Project	IEEE 802.16 Broadband Wireless Access Working Group http://ieee802.org/16 >
Title	Fixes for Network Entry Flow Charts
Date Submitted	2006-09-26
Source(s)	Nadav Lavi et al Alvarion Ltd. [Address Line 1] [Address Line 2] Voice: +97236457834 Fax: [Fax Number] [mailto:Nadav.lavi@alvarion.com]
Re:	
Abstract	Fixes for Network Entry Flow Charts in 802.16e
Purpose	For the review in 802.16 Maint TG
Notice	This document has been prepared to assist IEEE 802.16. It is offered as a basis for discussion and is not binding on the contributing individual(s) or organization(s). The material in this document is subject to change in form and content after further study. The contributor(s) reserve(s) the right to add, amend or withdraw material contained herein.
Release	The contributor grants a free, irrevocable license to the IEEE to incorporate material contained in this contribution, and any modifications thereof, in the creation of an IEEE Standards publication; to copyright in the IEEE's name any IEEE Standards publication even though it may include portions of this contribution; and at the IEEE's sole discretion to permit others to reproduce in whole or in part the resulting IEEE Standar

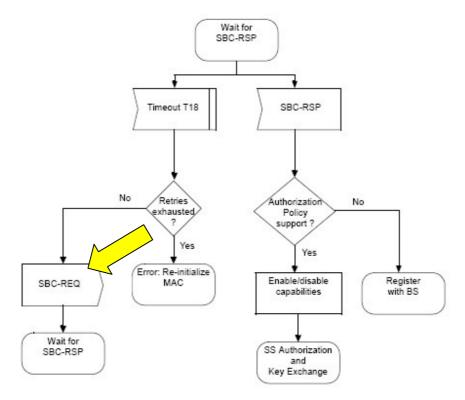
- 1. There is an unclear definition of how to handle expiration of T9 in the BS side in SBC transaction, and expiration of T17 in the BS side in REG transaction. The condition for "Release and age-out connections" is unclear and not well defined. In addition, this action is local to the BS and thus remains unknown to the SS. We suggest that the BS would send unsolicited RNG-RSP message with Abort instruction when these timers expire.
- 2. The current Network Entry flow chart cannot handle retransmission, either due to processing delays or message drop. After the BS transmits a response message, it will proceed directly to the next state in the Network Entry flow and thus cannot handle a retransmission of request by the SS; this would cause the Network Entry procedure to end in failure. For example, the following flow chart (Figure 67 in 802.16e-2005) shows that BS sends SBC-RSP.

If the SS does not receive SBC-RSP within T18 timeout, it will retransmit the SBC-REQ (Figure 66).

Replace Figure 67 in 6.3.9.7 with the following figure:

Figure 70—Registration—BS

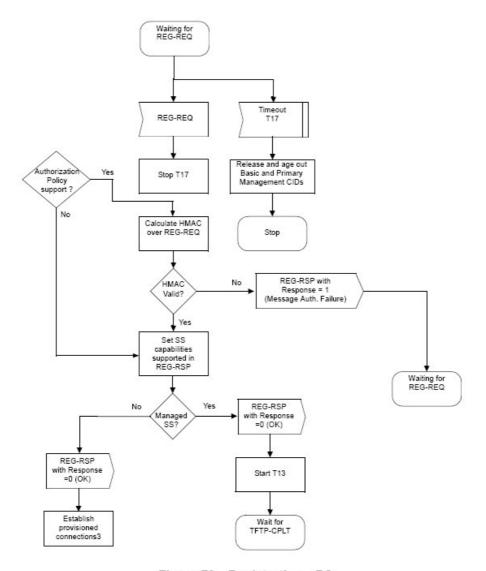
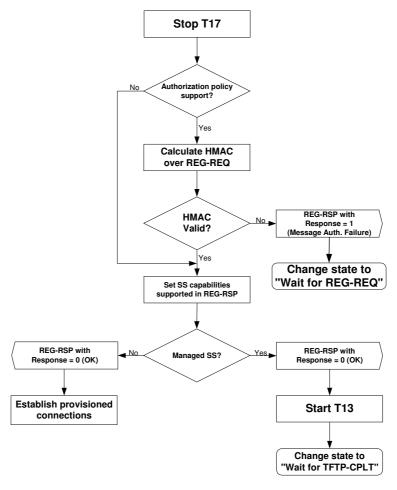
However after sending SBC-RSP, the BS proceeds directly to the registration step. The corresponding flow chart (Figure 70) does not contain any state where a retransmission of SBC-REQ can be received and processed. This is just an example of one single scenario. Similar failures can be identified for other steps in the entire Network Entry flow.

Replace Figure 70 in 6.3.9.9 with the following figure:

Figure 70 - Handling REG-REQ

Figure X – Network entry state-machine BS side (Applies only to OFDMA)

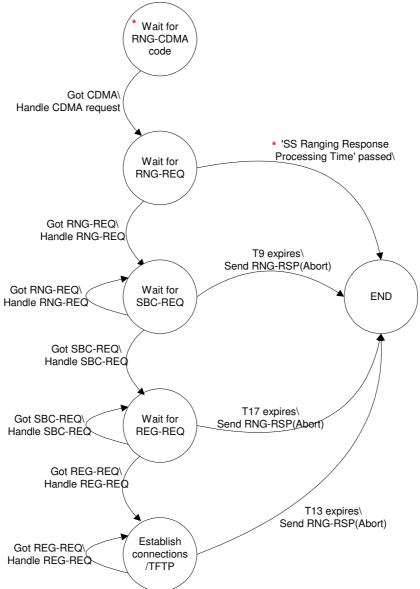
We suggest the Network Entry process be specified using 1) Network Entry state machine, and 2) set of actions/procedures of handling the Network Entry messages. This will provide a clearer definition of the network entry procedure as well as the handling of error/failure conditions.

Add the following Figure:
